SUBJECT: Informs of change to plant AMSAC design mod.

Docket 50-305
Operating License DPR-43
Kewaunee Nuclear Power Plant
TAC #59105
AMSAC Design Modification

LOGIC DIAGRAM

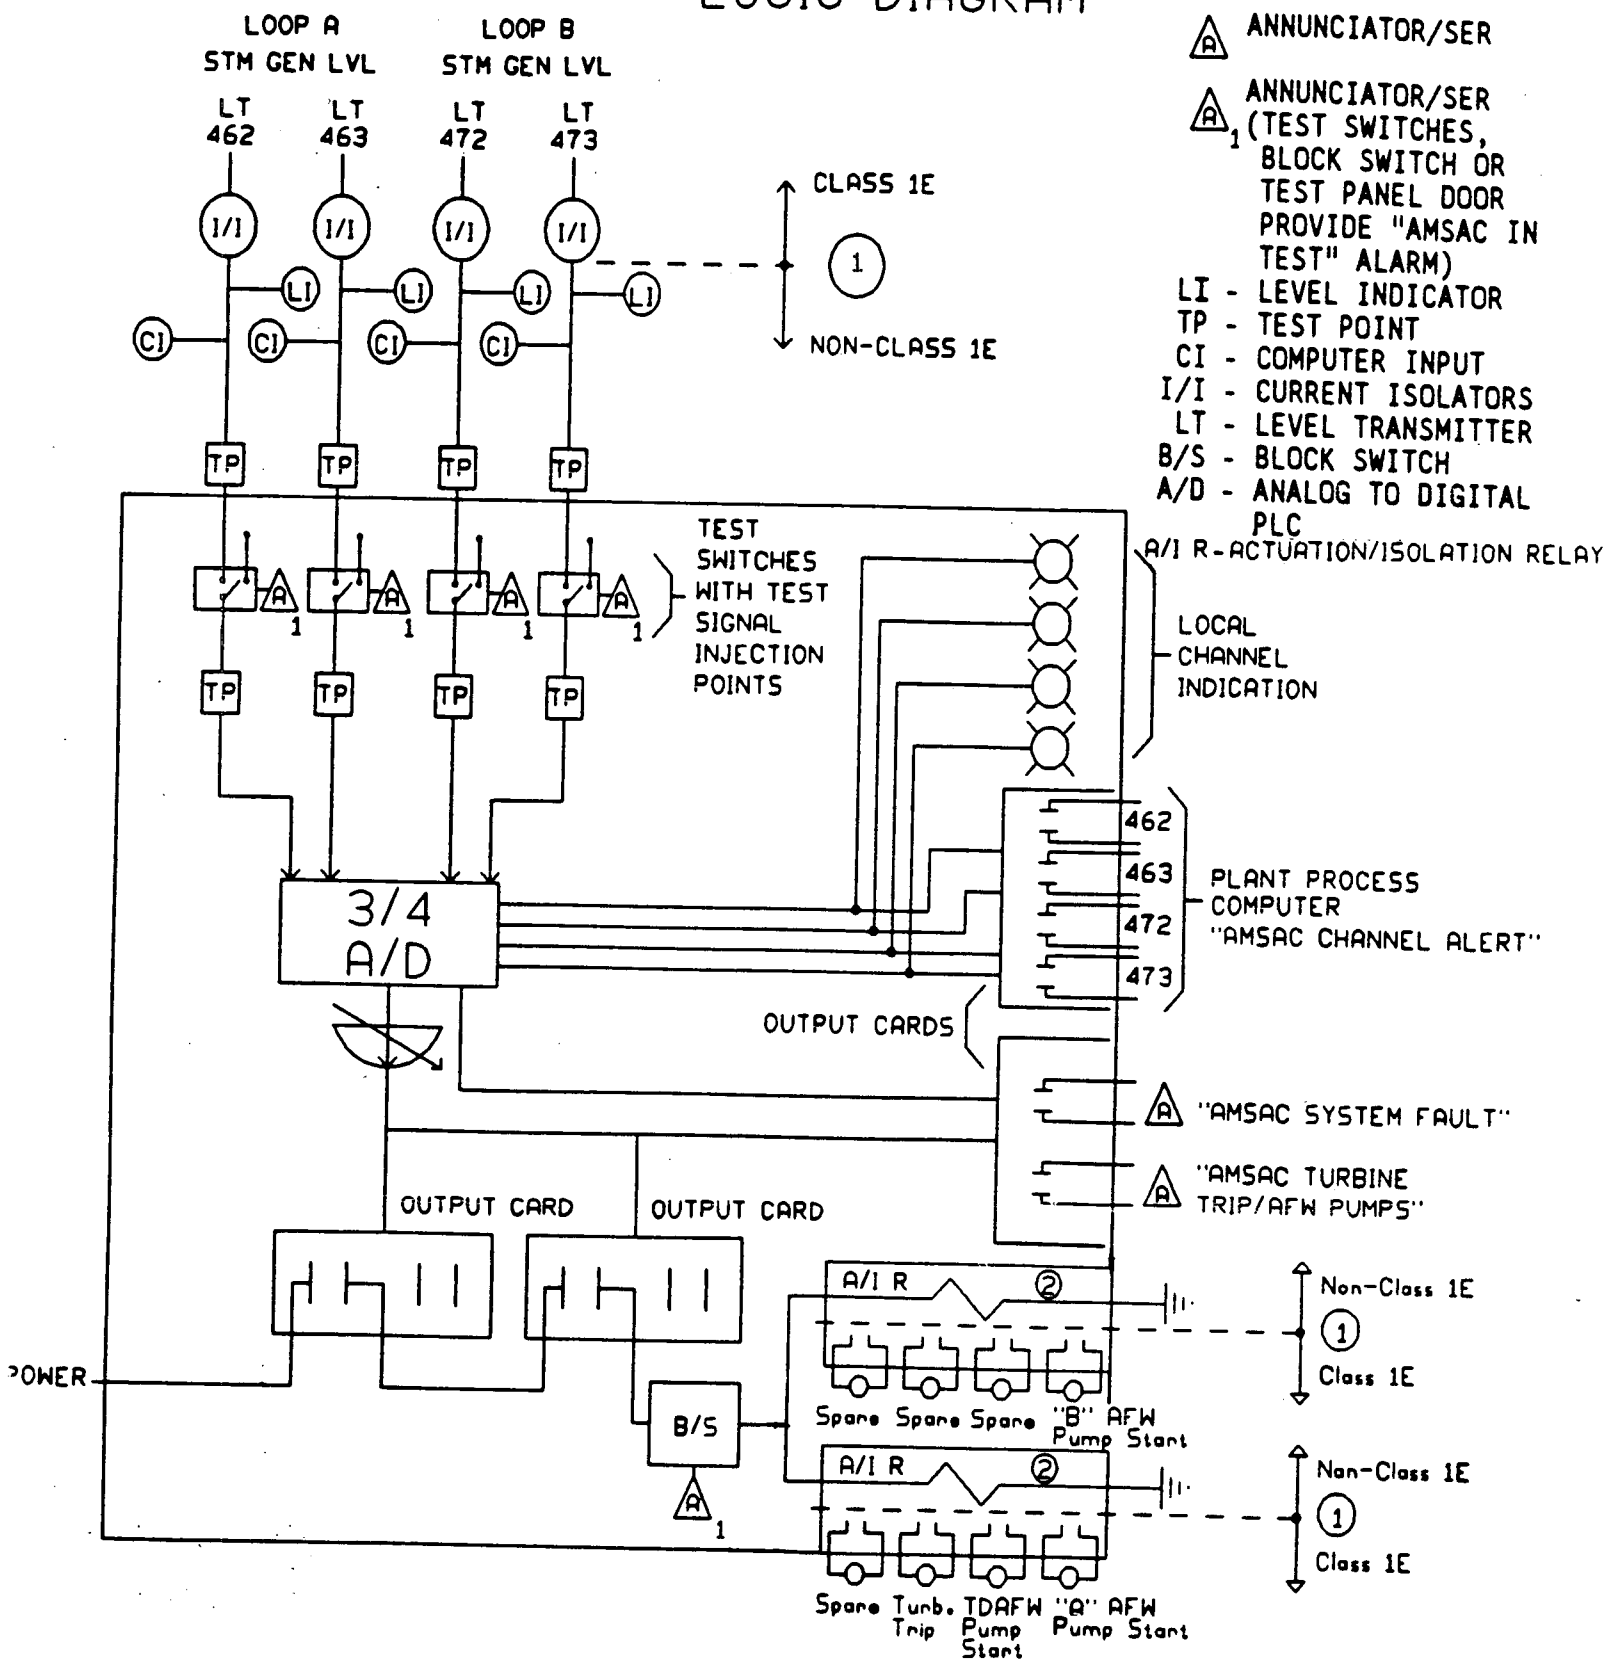
This letter is to inform you of a change to the Kewaunee Nuclear Power Plant (KNPP) AMSAC design as described in reference 1. The change consists of adding one actuation/isolation relay to ensure electrical separation between safety-related trains of equipment. This modification does not affect the design's compliance with 10 CFR 50.62, and in fact will more conservatively implement the electrical separation bases of the NRC's Safety Evaluation for the KNPP AMSAC design (reference 2).

Maintaining electrical separation is one of the main criteria whenever safety-related systems are modified at the KNPP. During independent reviews of the KNPP AMSAC design the use of one output relay to actuate two trains of safety-related equipment was questioned. The design used separate contacts on the actuation/isolation relay to actuate the two safeguard trains with contact separation providing the electrical train separation. In order to establish completely independent electrical separation we have elected to modify the KNPP AMSAC design and add a second actuation/isolation relay. This arrangement dedicates one relay to "A" train output signals and one relay to the single "B" train output signal ("B" Auxiliary Feedwater Pump Start).

The new configuration for the KNPP AMSAC design is shown on the attached Logic Diagram (Attachment 1) and Simplified Two-Wire Diagram (Attachment 2). These diagrams are modifications of diagrams which were submitted with reference 1. All other aspects of the KNPP AMSAC design, as described in reference 1, remain unchanged. All testing described in reference 1 for the AMSAC Actuation/Isolation Relay applies to both Actuation/Isolation Relays.

① THE CLASS 1E/NON-1E INTERFACE ISOLATION DEVICES ARE THE CURRENT ISOLATORS AND THE ACTUATION/ISOLATION RELAY.

② THE ACTUATION/ISOLATION RELAY COIL IS POWERED FROM A NON-CLASS 1E SOURCE. THE ACTUATION/ISOLATION RELAY CONTACTS ARE PART OF CLASS 1E ACTUATION CIRCUITS.
